Addendum #2
Solicitation # 20-99304
Snow Emergency Route Sign Installations

This addendum serves to notify all bidders of the following changes to the solicitation documents:

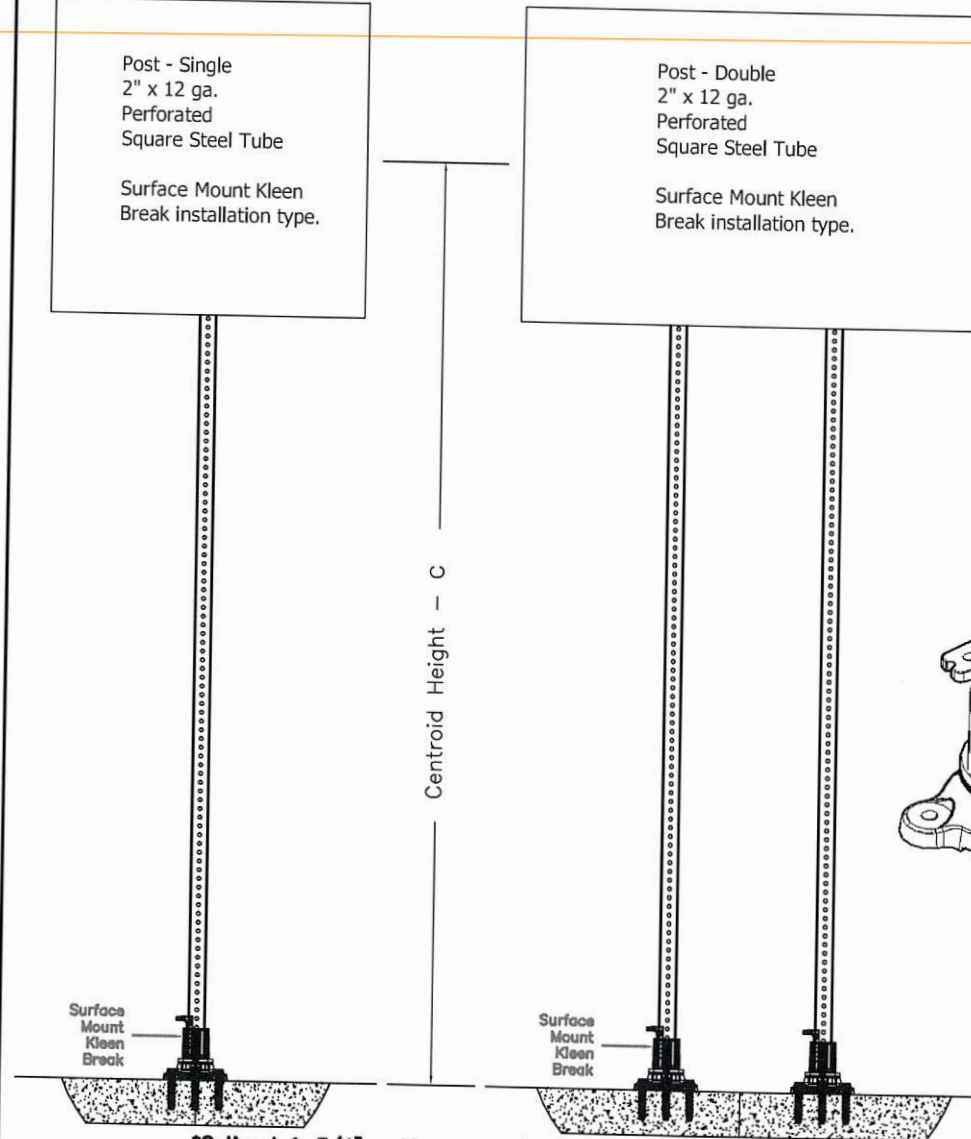
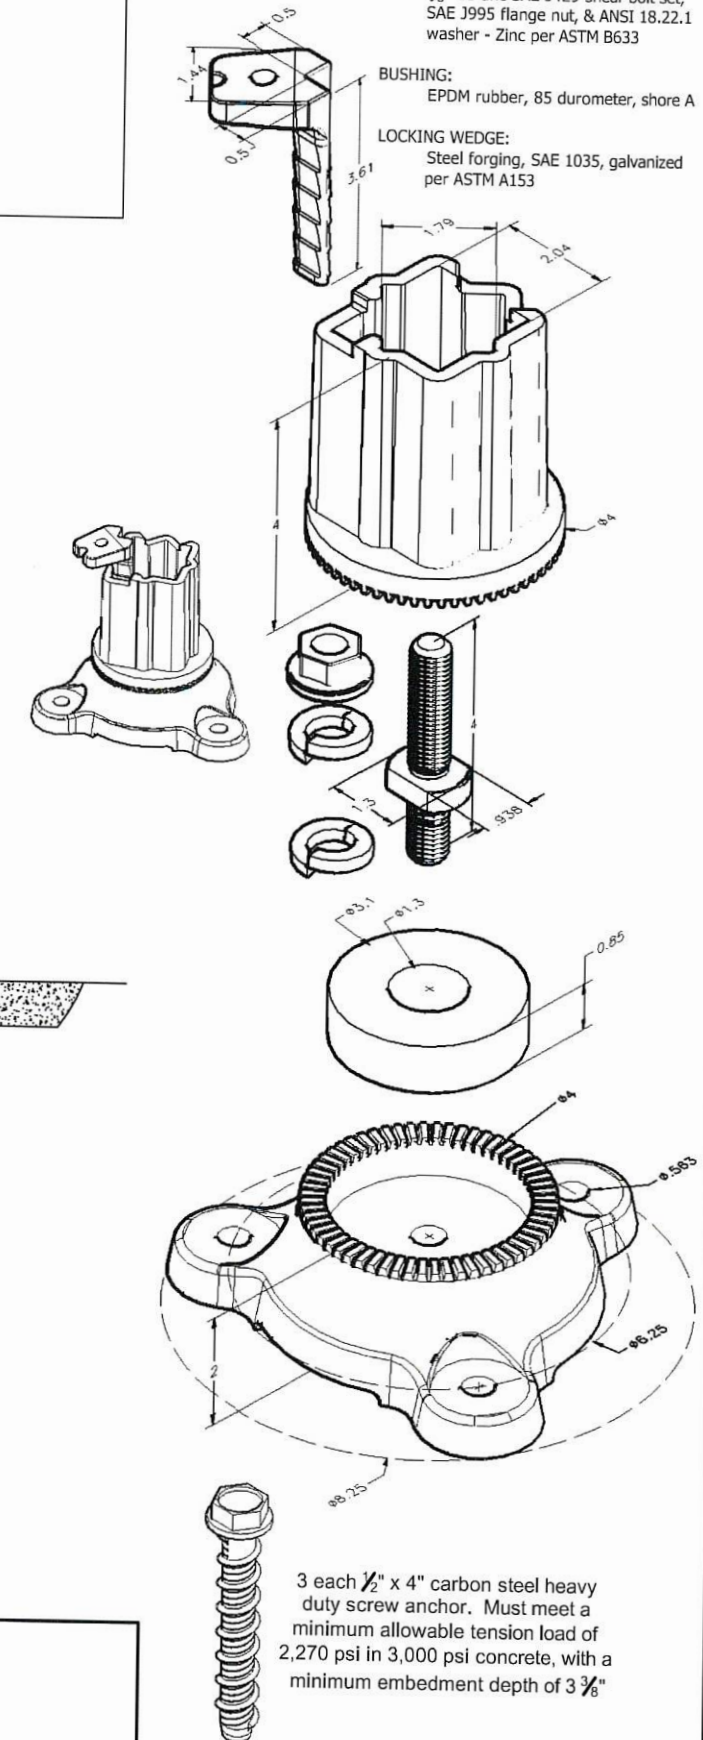
Delete Standard detail T-2. Replace with DWG# MN2018-1E dated 3/27/2020 and attached to this addendum. The internal sleeve is required (not optional) for the concrete surface mounts as per plan sheet 3 of 6, general notes.

All traffic posts installed shall conform to DWG MN2018-1E dated 3/27/2020, with use of MN/DOT approved/qualified products. All bases shall be located in an area clear of utilities to a distance of two feet in all directions, and a minimum of two feet behind the face of curb.

PERFORATED SQUARE STEEL TUBE POST, ANCHOR, & OMNI SLEEVE (PSST) SYSTEM:

POST: 2" x 12 ga. x appropriate length
ANCHOR: 2 1/4" x 12 ga. 48"
OMNI SLEEVE: 2 1/2" x 12 GA. x 48" and shall contain four 4" x 10" x 12 ga. pre-galv ASTM A569 steel fins welded to each of the four corners, starting 6" down from top of sleeve and must be spray galvanized after welding.

Perforated Square Steel Tube shall be ASTM A1011, Grade 50 steel (ASTM A653, G90) with an average minimum of 60,000 psi yield strength, after cold-forming. It must be corner welded, scarfed after welding, and zinc coated after scarfing. A chromate conversion coating and a clear organic polymer topcoat shall be applied. Interior and exterior shall be galvanized. Tube shall be perforated with 7/16" holes, spaced 1" apart, along the centerline the entire length on all four sides.

PERFORATED SQUARE STEEL TUBE POST (PSST), SURFACE MOUNT KLEEN BREAK SYSTEM.

*Optional 1-3/4" x 12 ga. x 36" internal sleeve may be used to stiffen the post for low speed impacts
